**THE CORPORATION OF THE
TOWN OF GEORGINA
Special Council Addendum Agenda**

Report No. DS-2023-0096

**SUBJECT: OFFICIAL PLAN AND ZONING BY-LAW AMENDMENT APPLICATIONS
LOTS 1 TO 15, BLOCK A AND DOREDA DRIVE, PLAN 447, AND LOT
5 AND PART OF LOTS 6 AND 8, PLAN 170
232 CAMERON CRESCENT, KESWICK**

**Re: 1st Submission- Official Plan Amendment 02.207 & Zoning By-law Amendment 03.1180
(Keswick Lighthouse Developments)
230, 232, 236 & 240 Cameron Crescent, Keswick
Lots 1 – 15 and Block A and Doreda Drive, Registered Plan 447 / Lot 5 and Part of Lots
6 and 8, Registered Plan 170
Town of Georgina
Regional File Nos.: LOPA.23.G.0063 & ZBA.23.G.0102**

DRAWING TITLE
Site Plan

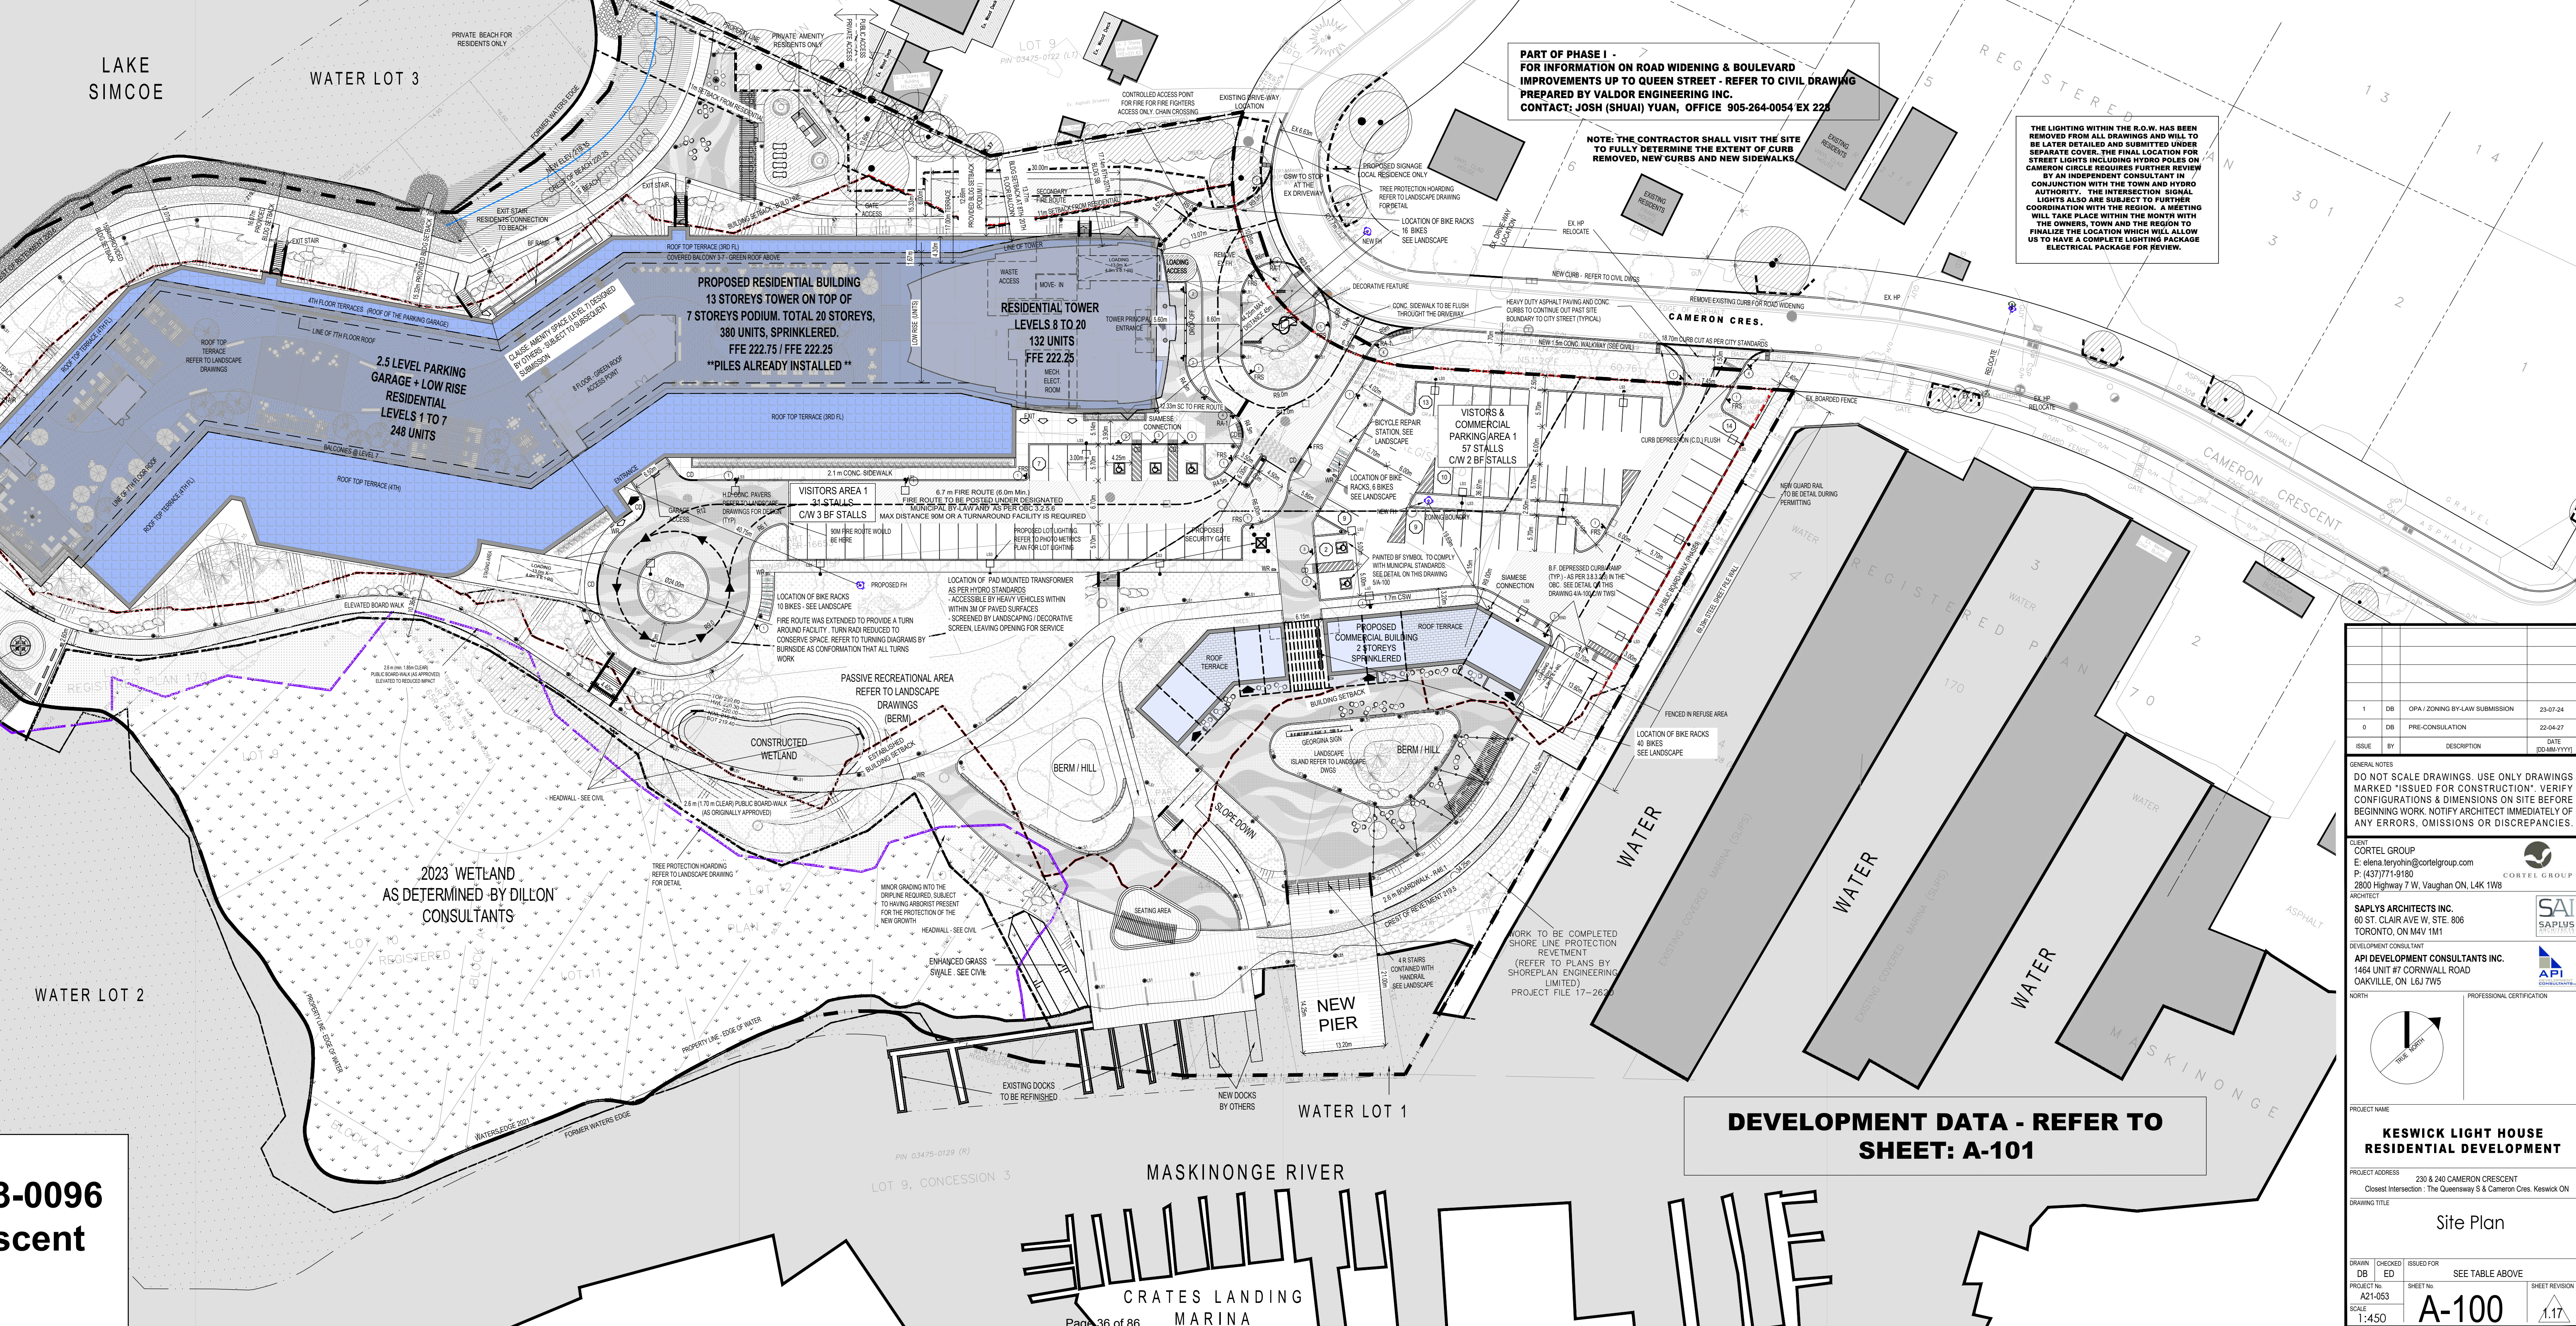
The limit of the on-site wetland shown on the submitted Site Plan differs from the wetland limit staked by the LSRCA. Confirmation of the new proposed wetland limit needs to be provided by LSRCA staff via site visit during wetland staking season.

Section 7.0 Site Plan Review:

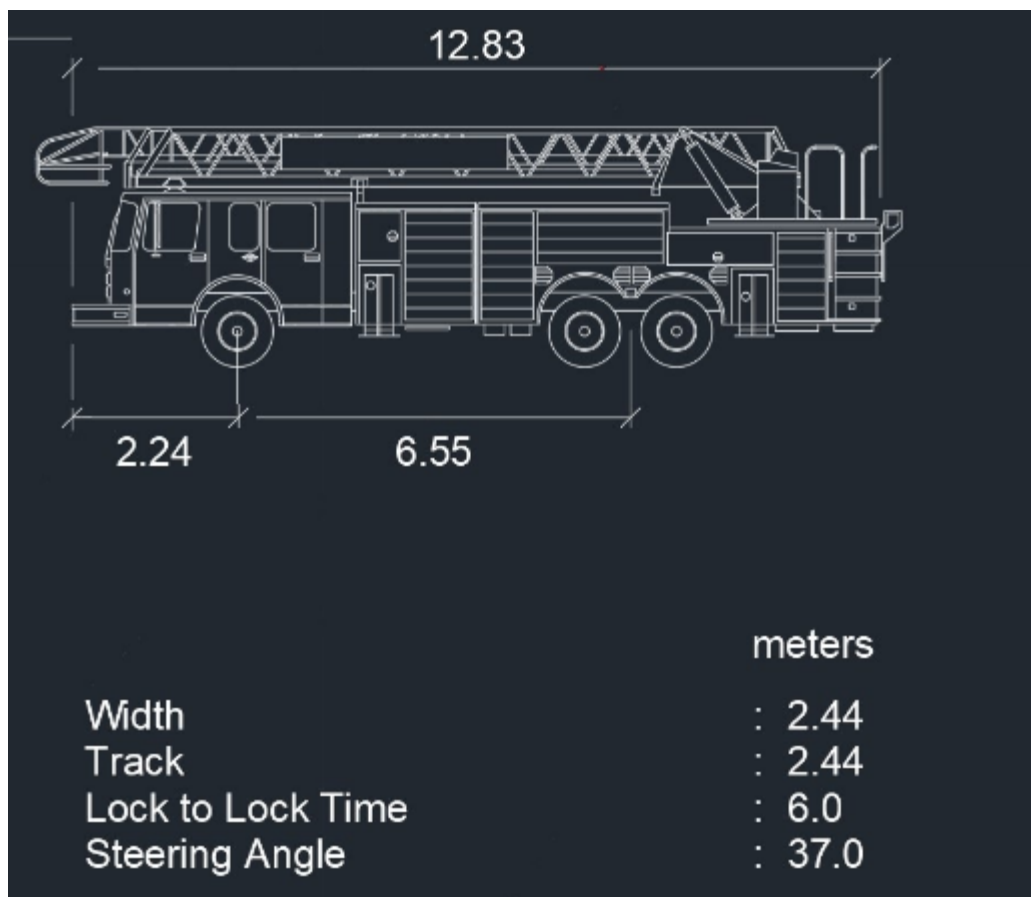
3. The access analysis conducted by Burnside to confirm fire truck access was carried out with a Pumper Fire Truck (length of 10.08 m and wheelbase of 5.08 m), which is considerably shorter than an Aerial Fire Truck and therefore does not represent the largest fire truck that may need to access the site. The Town's standard fire truck design vehicle is shown in the figure below (length of 12.83 m and wheelbase of 6.55 m). We recommend that Burnside update the fire truck access analysis using this design vehicle.

SBM conducted cursory vehicle path analysis with the Town's standard size of fire truck and found that the turnaround circle at the parking garage entrance is not quite large enough to allow the fire truck to circulate around the circle. It appears increasing the turnaround circle diameter to a minimum of 26 m would be needed.
